MODIFICATION REQUEST:
Block 2; 'One Central Park'
26 Broadway, Chippendale
(Former Carlton & United Breweries Site)

Modification MP09_0078 MOD 3

Director-General's
Environmental Assessment Report
Section 75W of the
Environmental Planning and Assessment Act 1979

December 2011

Figure 7: West elevation (Chippendale Way) Approved

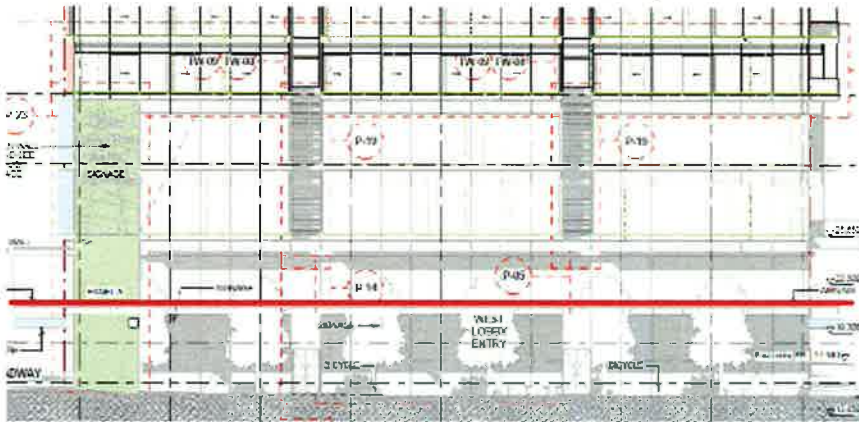
The proposal seeks approval to raise the height of the approved awnings to the Chippendale Way, Carlton Street and Broadway elevations, from the Level 1 datum line to align with the Level 2 datum line, consistent with the top of the retained historic Brewery Gate to Broadway. In addition, the approved awning to Carlton Street will be increased to run the full length of the elevation and its depth will be increased to 3m, consistent with other approved awnings.

The Level 2 datum line is consistent with the height of the top of the retained historic Brewery Gate on Broadway, at the entrance of Carlton Street. The approved and proposed awning heights are illustrated in **Figures 7-9** below (shown in red).

The Department considers that the revised awnings provide an improved street appearance, providing for a grand, double height street elevation. The raised height and size of the awnings is considered to be consistent with the flagship role of the building and the proposed modification is therefore supported.

Figure 9: East elevation (Carlton Street) Approved

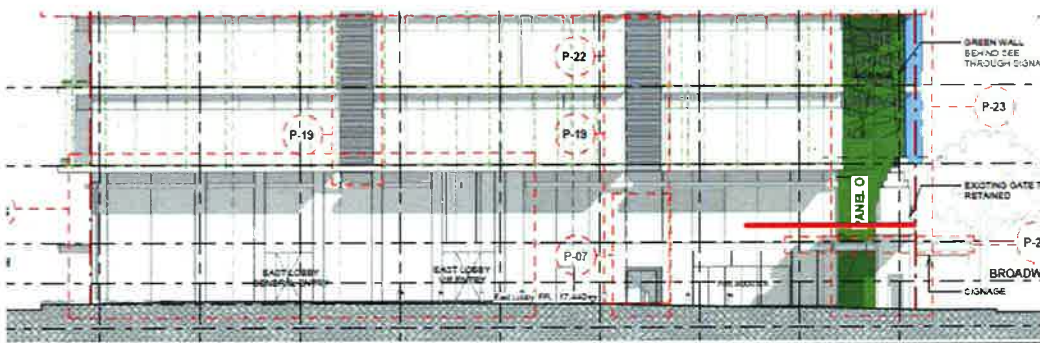
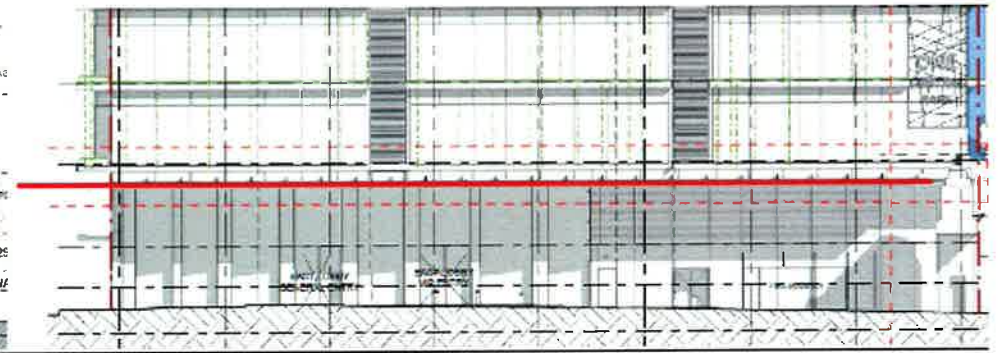
The proposed modification is supported by a heritage statement advising that the proposed modified awning to Carlton Street provides adequate separation from the heritage Brewery Gate on Broadway, so as to maintain the heritage significance of the gate.
